Service Bulletin No. 444

MODEL J4500	TYPE Field Change Program	SECTION/GROUP 7-Electrical	DATE March 2, 2017
SUBJECT HAMSAR HIGH MOUNT BRAKE LIGHT WATER INTRUSION			
CONDITIONS

Figure 1. High mount brake light location.

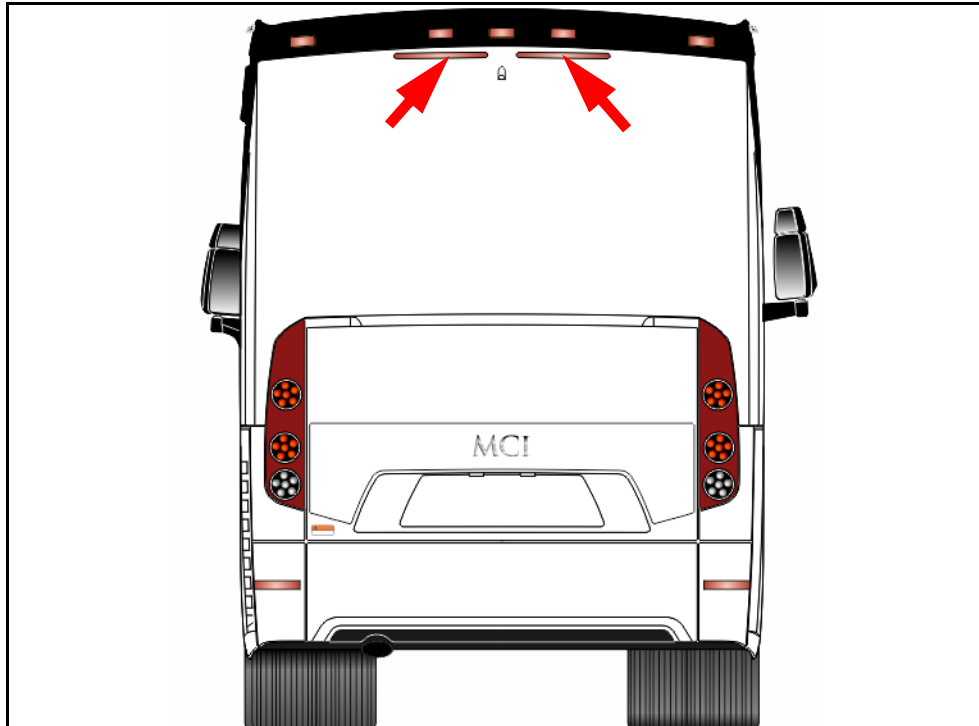
Customer Complaint:

Hamsar has notified Motor Coach Industries ("MCI") that the potential may exist for the high mount brake light to fail due to water intrusion.

Delamination of the back plate sealant may result in water intrusion and damage to internal components of the light assembly.

1. Turn the main battery disconnect switch to the OFF position.
2. Chock both sides of the tires.
3. Locate the existing high mount brake lights on the upper section of the coach rear cap.

4. Remove and retain the high mount brake light mounting hardware.
5. Disconnect and discard the high mount brake light.
6. Using a 50/50 mixture of isopropyl alcohol and water, clean the installation area.
